Re: 5645 Hansel Ave. Response to Comments

Re: Review of Mecatos Site Plan Submittal

RE: 5645 Hansel Ave – Mecatos Bakery and Cafe – construction plan review
CPH project number E7601

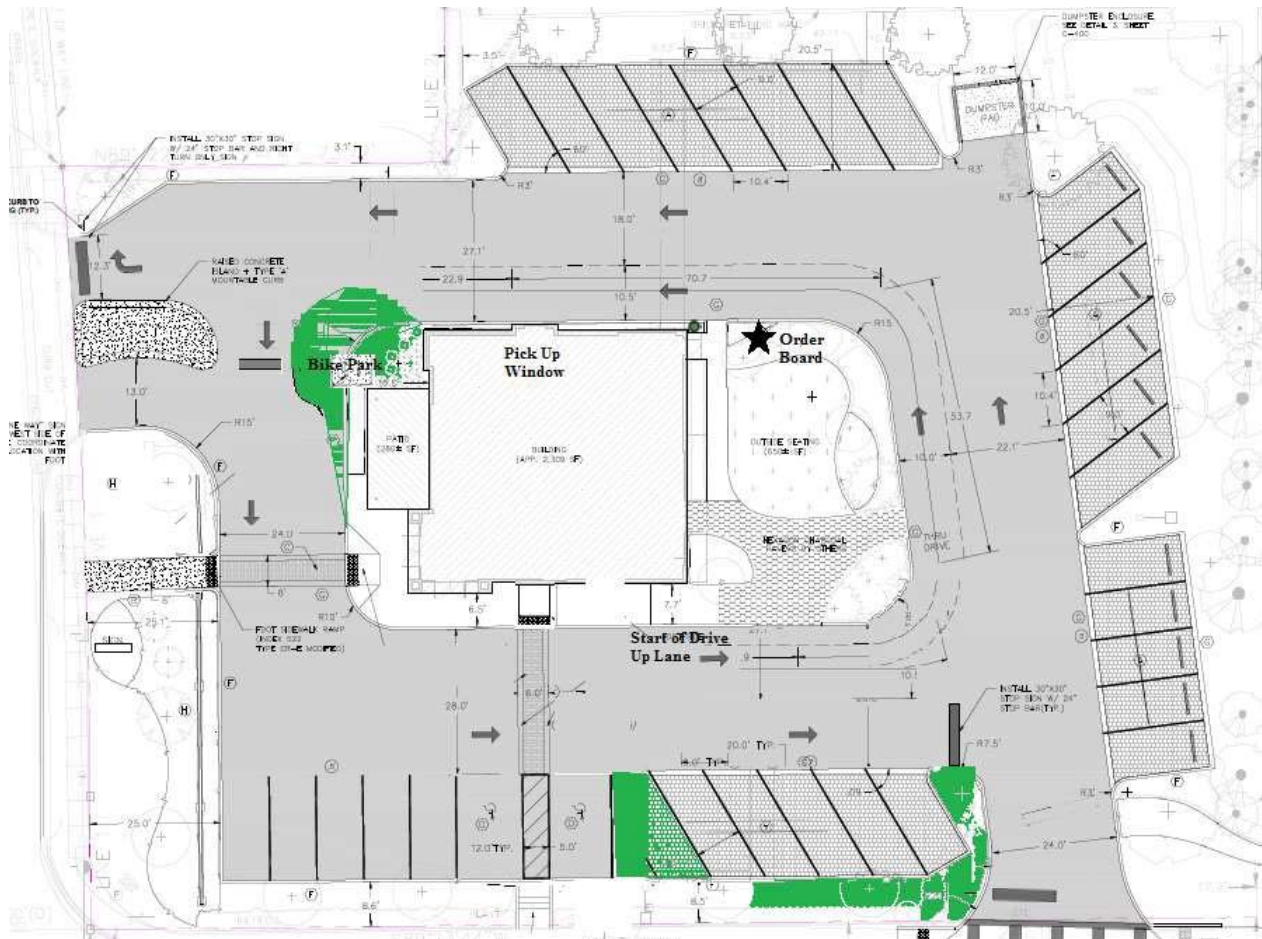
Whereas it is reasonable to put the bicycle parking behind the street wall, the wall should then return to the required location. An alternative would be to move the bicycle parking to another location (see a potential site on the next page).

Action Needed: Redesign the buffer width and street wall location or request a waiver. (I will submit waiver for street wall location(25 feet + 2 feet + width of wall)).

Recommended Action: relocate the bicycle parking and provide envisioned ECD design.

Drive-up Window Location and Queue Lane

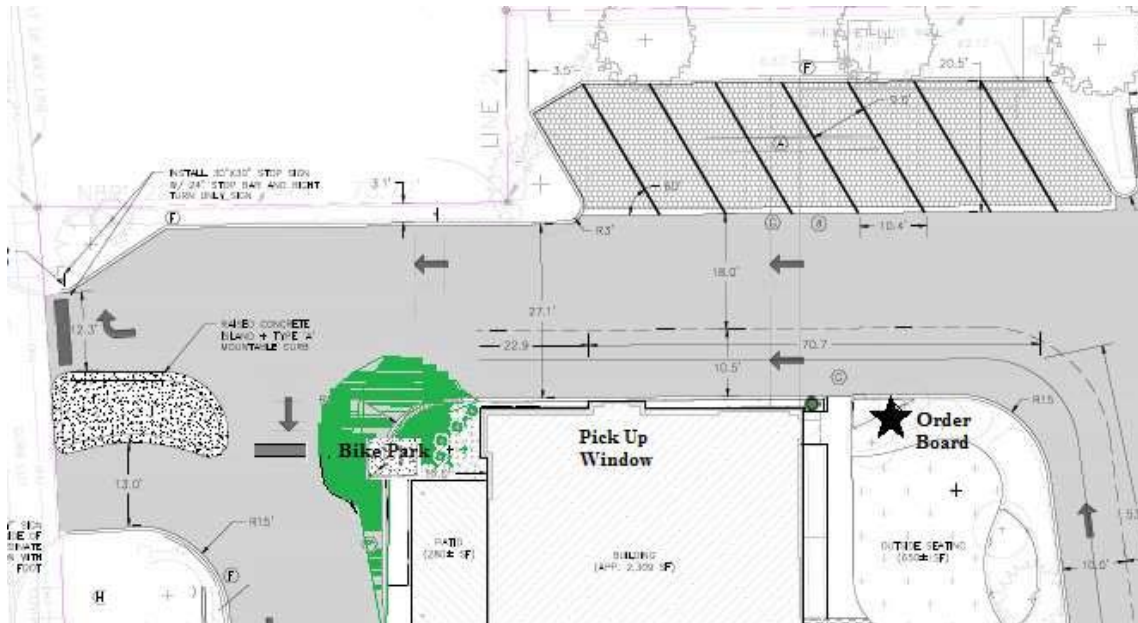
The applicant is requesting a waiver from Code Section 134-472(b), which requires drive-up windows to be designed on the rear of the building and to incorporate a drive up lane of a minimum of 120 feet in length as measured from the first stopping point; e.g., the order board. Due to using an existing building, the most practical location for a pick up window from the internal bakery floor plan perspective is on the north side. It would be impractical to locate the window in the rear. Staff can support this location with a condition for redesign of the front elevation with a faux wall or landscaping to “hide” the window from Hansel Avenue (see illustration).

Staff supports approval with the condition of screening the drive through lane/window from Hansel Avenue. The condition will help to,

Action Needed: Redesign to screen the drive through lane/window from Hansel Avenue. (Not accepted.)

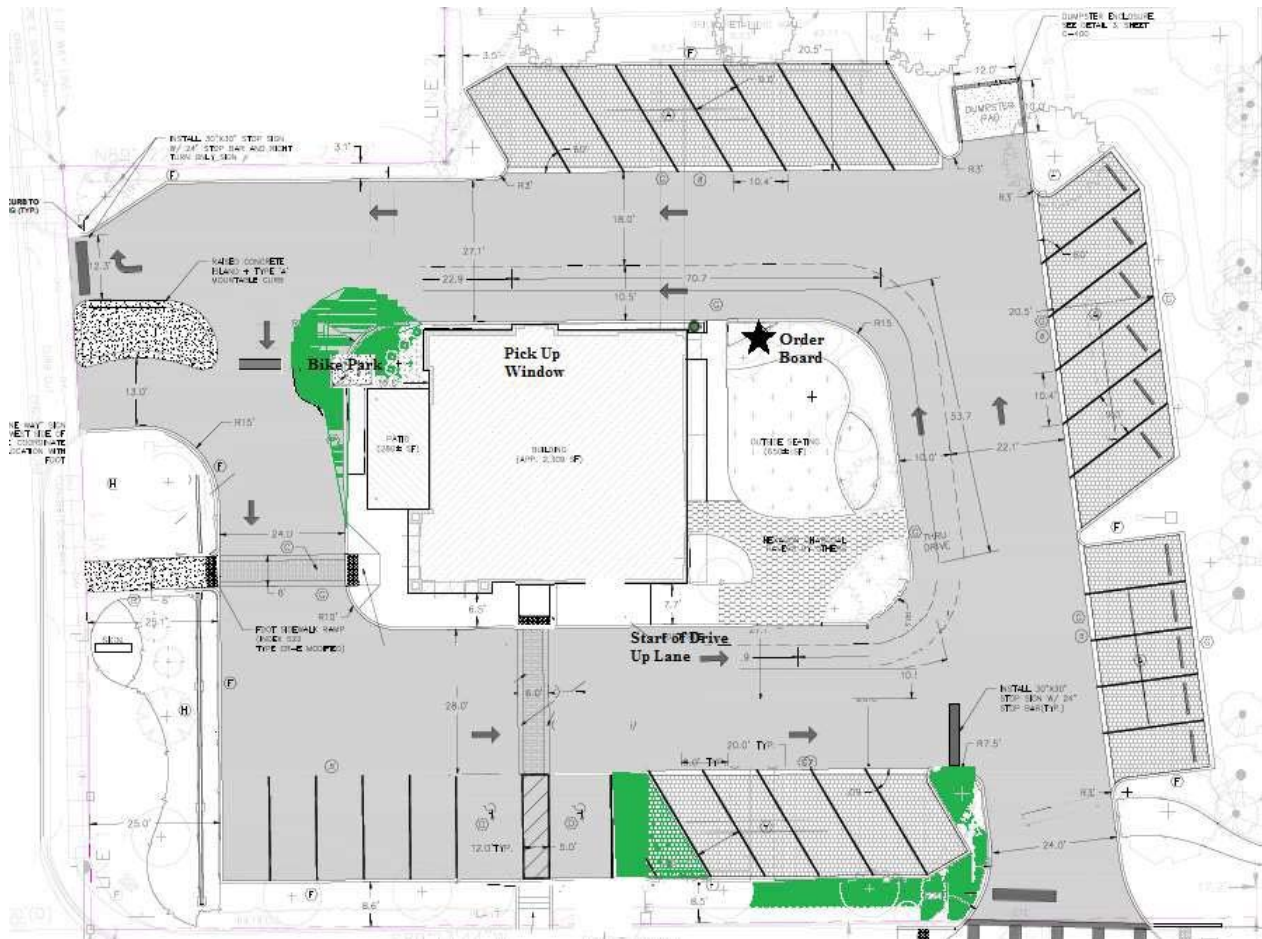
The second waiver related to the drive-up window is the queue length. The menu board/order location is not identified on the site plan, however is identified on the landscape plan. The proposed queue at the order board is 57 feet, only accommodating the ordering vehicle and one waiting. Code requires 120 feet, accommodating one at the order board and five waiting. The queue length can be increased by moving the order board to the west and using the northern 10.5 feet of part of the east/west drive aisle (after conversion to one-way) as illustrated on the next page. No parking spaces are lost in this alternative design.

In addition, an increase in queue length is recommended by moving the order/menu board five feet east of the sidewalk from the outdoor patio to the north parking area. Staff recommends provision of a cross walk and adding pavement striping to delineate the drive through lane staff recommends approval. This will help to serve the health, safety and welfare of the city.
